# 1984 Corvette: Service Bulletin: Rack / Pinion Power Steering Valve Ring Service

**Subject:** RACK/PINION POWER STEERING VALVE RING SERVICE

**Model and Year:** 1981-84 CHEVETTE, 1982-84 CAVALIER, CELEBRITY, CITATION AND 1984 CORVETTE

**Bulletin Number:** 84-74 - (06/02/1984)

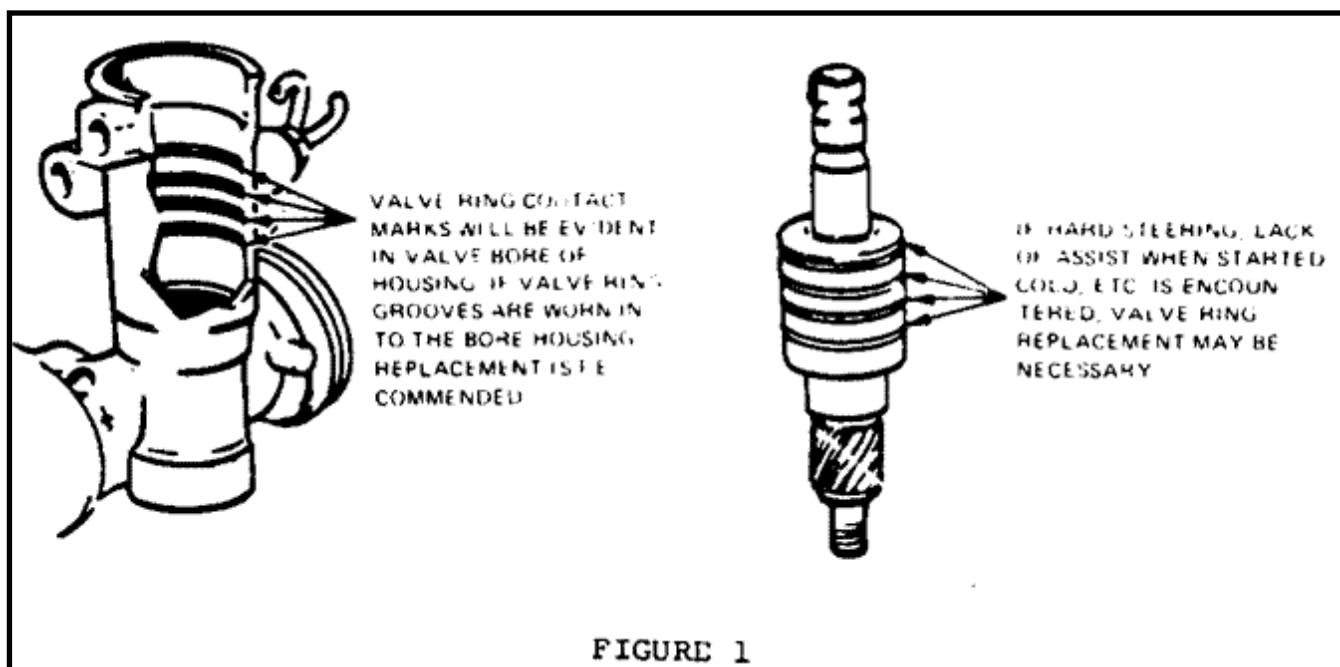
The design intent is that valve rings will remain stationary in the bore of a power rack and pinion assembly. If hard steering, lack of assist when started cold, etc., is encountered with normal pump pressure, inspect the rack and pinion housing valve bore (see illustration).

Ring contact marks in the valve bore is normal. If ring groove wear exists, replacement of the housing is necessary to assure that replacement rings will not eventually wear further into the housing and result in a recurrence of a lack of power assist symptom.

If only one (1) or two (2) of the four (4) ring contact marks in the housing have resulted in ring groove wear, the corresponding ring land of the valve is most likely causing excessive ring drag. Replacement of the valve as well as the housing would then be required.

In mid-1984, the rack and pinion housing valve bore will have a textured finish to further insure valve ring retention to the bore. The textured area in

the bore will be the circular band sealing ring surface corresponding to the four (4) rings in the valve body.

FIGURE 3

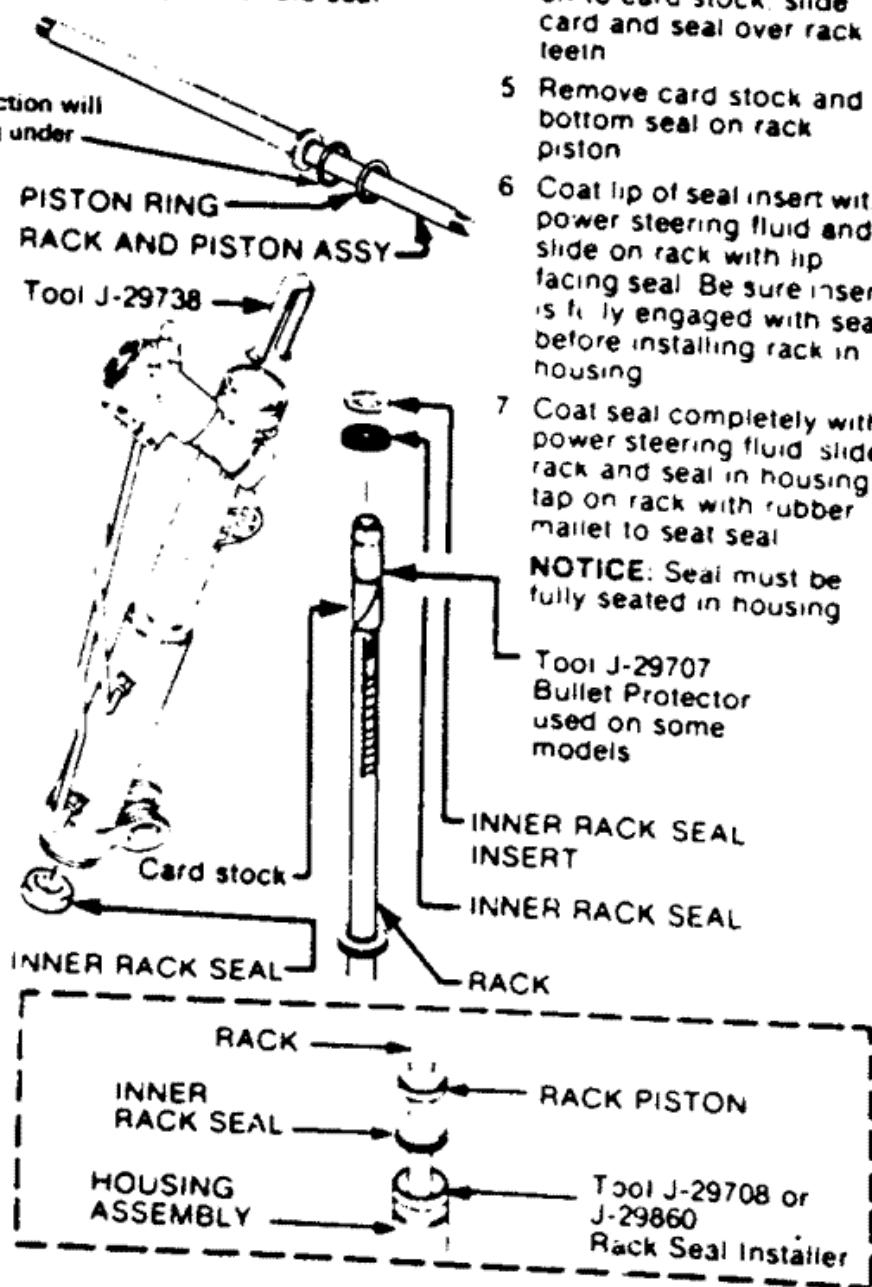
- 1 Remove rack from housing
- 2 Remove piston ring and dispose
- 3 Fit tool J-29738 into housing. Using rod approx 12" long, gently tap on rod until seal is removed
- 4 Dispose of old seal

Mid 1984 production will have an "O" ring under piston ring.

- 1 Install new piston ring on rack
- 2 Care should be taken not to cut ring at installation
- 3 Wrap card stock around end of rack and rack teeth
- 4 Coat seal lip with power steering fluid. Slide seal with seal lip facing piston on to card stock. Slide card and seal over rack teeth
- 5 Remove card stock and bottom seal on rack piston
- 6 Coat lip of seal insert with power steering fluid and slide on rack with lip facing seal. Be sure insert is fully engaged with seal before installing rack in housing
- 7 Coat seal completely with power steering fluid. Slide rack and seal in housing. Tap on rack with rubber mallet to seat seal

**NOTICE:** Seal must be fully seated in housing
